**S-TYPE**

**S100-05**

**TECHNICAL BULLETIN**

**S-TYPE Enhancement Program –  
Service Action S120**

ILLUSTRATION 2

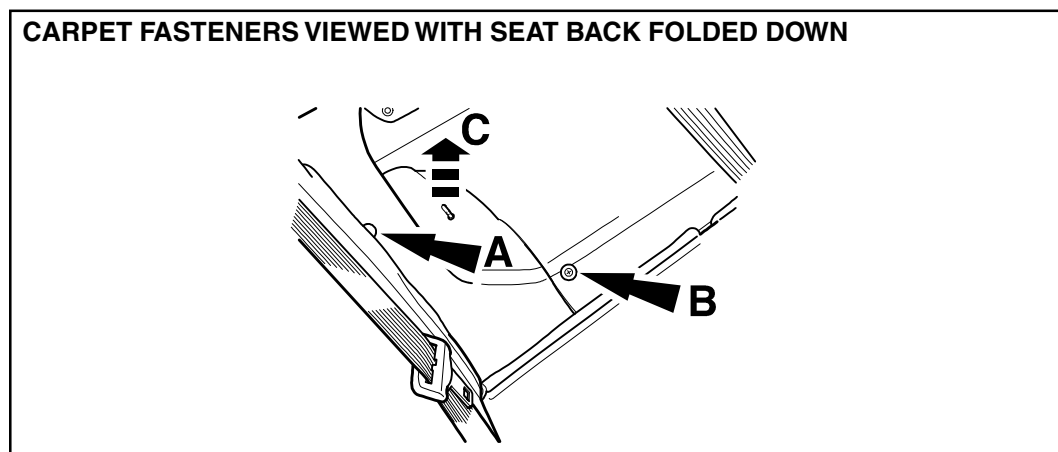
2. Working through the right side rear door, pry out the fir-tree fastener 'A' in Illustration 2. Release (1/4 turn) the fastener 'B' and pry it from the carpet of the luggage compartment. This illustration shows the carpet fasteners arrowed as 'A' and 'B' on the right hand side of the vehicle, as viewed through the right hand rear door, looking rearwards. Arrow 'C' indicates that the side carpet must first be raised clear of the hook before it can be released and repositioned towards the right hand side of the luggage compartment. Left side of vehicle is a mirror-image of this view.
3. Via the left rear door, remove the similar fasteners on the opposite side of the vehicle.
4. Roll the center section of the carpet rearwards into the luggage compartment.

5. On one side, raise the side carpet clear of the projecting hook in the luggage compartment floor ('C', Illustration 2). Release the side carpet from the trim against the side of the vehicle until the front portion can be rolled clear sufficiently to provide access to the areas shown in Illustrations 3 and 4. Repeat for the opposite side of the vehicle.

ILLUSTRATION 3

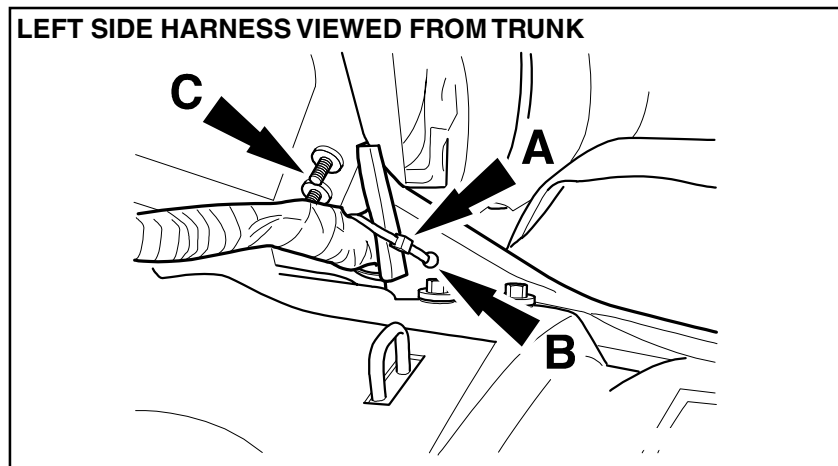
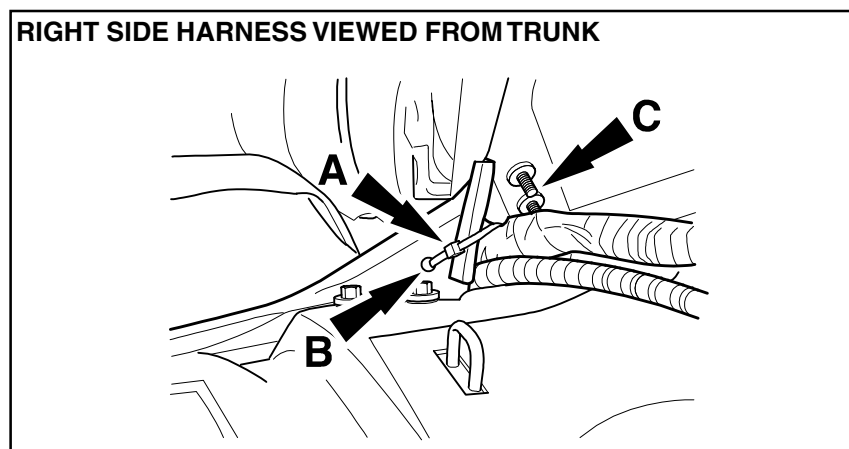
6. On the left side, pass a tie-strap 'A' through the hole 'B' in the body stiffener plate and then around the main body harness. Tighten the tie-strap so that the body harness is retained away from the threads of the two securing bolts 'C', and cannot become chafed on these bolts. Cut off the excess length of tie-strap.
7. Repeat item 6 at the right side, noting that on this side the tie-strap passes around the main battery feed cable in addition to the body harness.
8. Reinstall the portions of the side carpet, taking care to tuck them under the trim at the side of the vehicle to restore the original appearance and to permit the fir-tree fasteners to be reinstalled in their original locations without any distortion of the side carpets. Roll the center section of the carpet forward to its correct location before installing the fir-tree fasteners shown at 'B' in illustration 2.

ILLUSTRATION 5

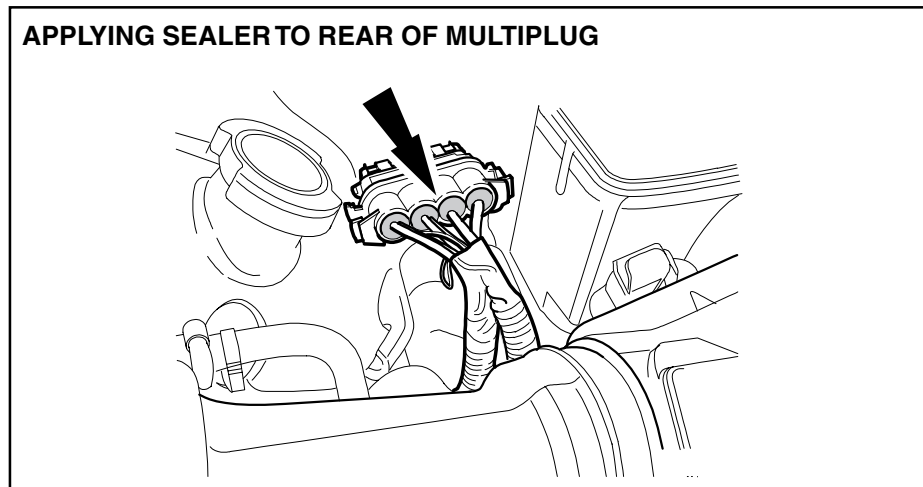
8. Apply a suitable cleaning fluid to the rear face of the harness multiplug; blow with an airline until completely dry.
9. Using a tube of polyurethane-based sealer, trim the tip of the nozzle to allow sealer to be injected into the rear face of the harness multiplug so as to seal the entry of the wiring into the multiplug. **It is necessary to use a polyurethane-based sealer and not a silicone-based sealer due to sealing abilities of the polyurethane.** Fill each of the 4 large cells of the plug until the sealer is flush with the rear face of the plug and adhering to the wiring (Illustration 5).

10. If possible, allow time for the sealer to partly-dry or cure before reinstalling the multiplug to the module and correctly locating the harness into its retaining clips. Where convenient, allow drying or curing to occur overnight.
11. Reinstall the cable clips to retain the harness. Remove the fender covers and close the hood.

ILLUSTRATION 6

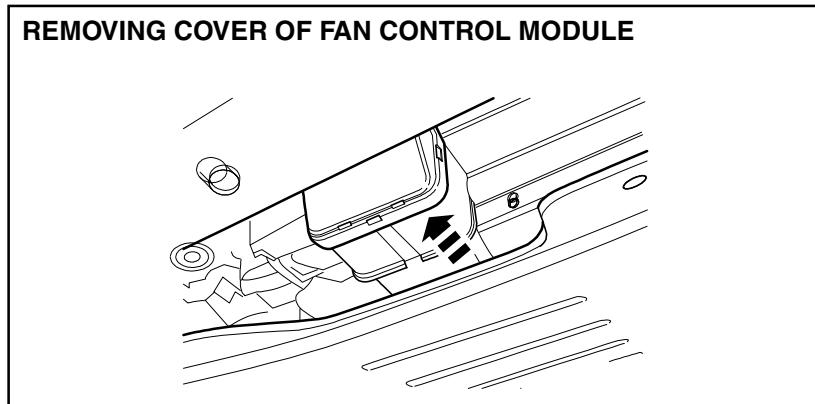
14. Release the 5 plastic tangs which retain the cover of the Fan Control Module and remove the cover, (Illustration 6).
15. Remove the retaining bolt from the rear of the module (Illustration 7). Move the module upwards until there is sufficient clearance for it to be removed. Install the replacement unit by a reversal of the above procedure.

ILLUSTRATION 8

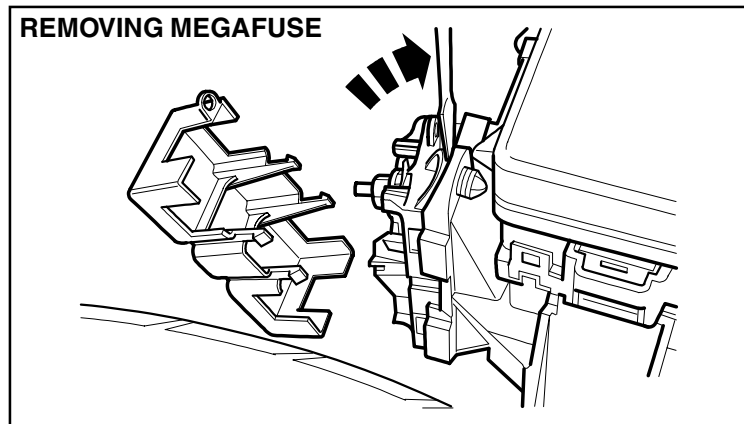
1. Disconnect the battery. Remove the spare wheel and jack to improve access.
2. Locate the Megafuse which is attached to the front face (nearest the rear seat) of the Rear Power Distribution Box, on the right hand side of the luggage compartment.
3. Release and remove the cover - located by 4 tangs (Illustration 8).

4. Remove the terminal nuts and disconnect the power leads. **Note their locations to assist in reassembly.**
5. Carefully pry the Megafuse away from the Rear Power Distribution Box - it is retained by captive 'fir tree' fasteners. Discard the old megafuse.
6. Install the new megafuse part no. XR8 12486. Torque the terminal nuts to 9.5 Nm. Reassemble in reverse order.
7. Reset the clock.
